# Scoping Report.

REQUEST FOR SECRETARY'S ENVIRONMENTAL  
ASSESSMENT REQUIREMENTS

## ATTACHMENT 12 SCOPING CONSULTATION – TSC

**From:** [Colleen Forbes](#)  
**To:** [Lance Newley](#)  
**Subject:** Hanson Tweed Sand Plant - Pre-SEAR's Scoping Submission / Consultation - TSC Feedback  
**Date:** Friday, 8 November 2019 1:19:17 PM

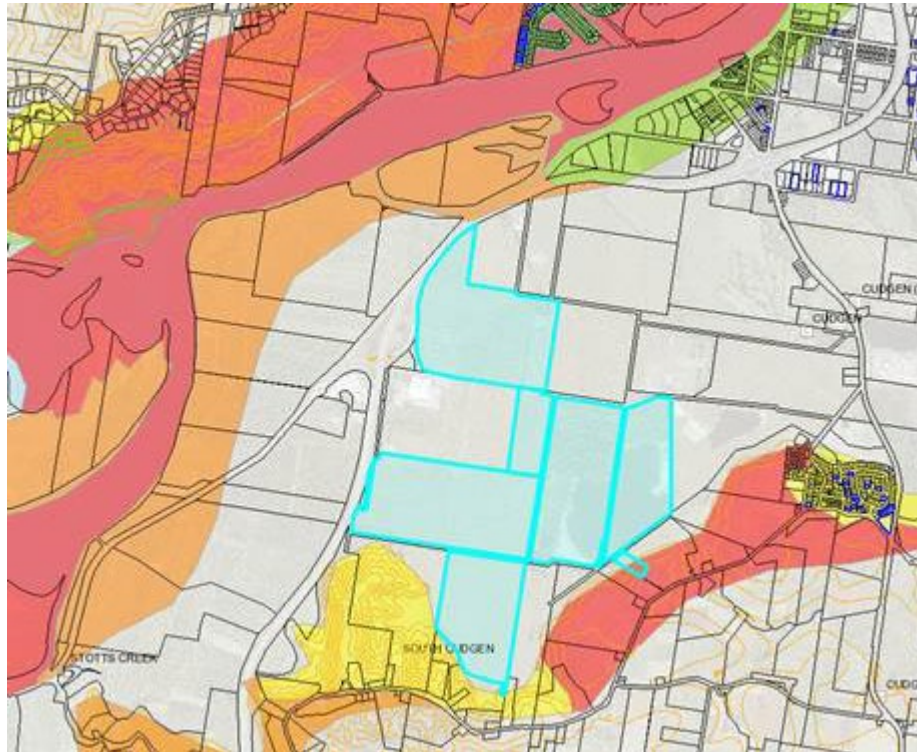
- Far North Coast Regional Strategy. Whilst the Strategy may identify *Regionally Significant Extractive Resources* in the Chinderah Road area, it is also noted that the Strategy provides for the protection of productive farmland from development pressures, with the subject area being mapped as *Regionally Significant Farmland*.
- North Coast Regional Plan 2036. Concern is raised with the suitability of the proposed development and the impact of sterilizing the land for future uses and loss of agricultural land.
- A significant portion of the site is recognised as Regionally Significant Farmland under the Northern Rivers Farmland Protection Project.

- The majority of the site is mapped as being Agricultural Land suitable for Grazing Land or land well suited to pasture improvement.

- A significant portion of the site is mapped as having a Land Capability suitable for Regular Cultivation.

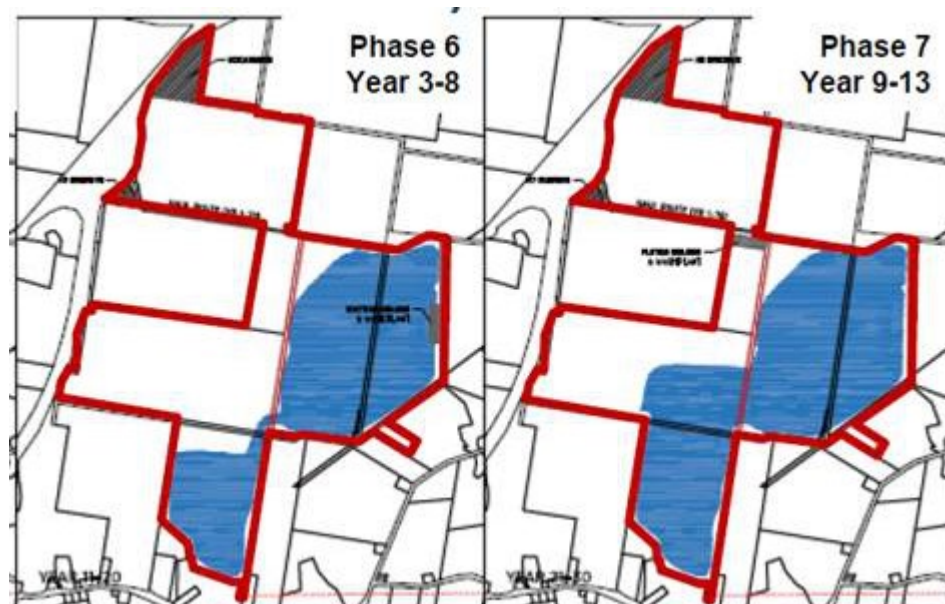
- The proposal is not clear on what the ultimate end use of the site will be and how the proposal will be maintained in the long term.
- Noise / amenity impacts associated with the proposed 24/7 hours of operation for the dredging and haulage of sand need to be investigated.
- The proposed truck routes need to be clear for all stages of the proposal. The documentation provided to date appears to indicate access to the Motorway from the initial stages of the expansion, yet the site building / wash plant does not relocate to the northern boundary until Phase 7 (Year 9-13).
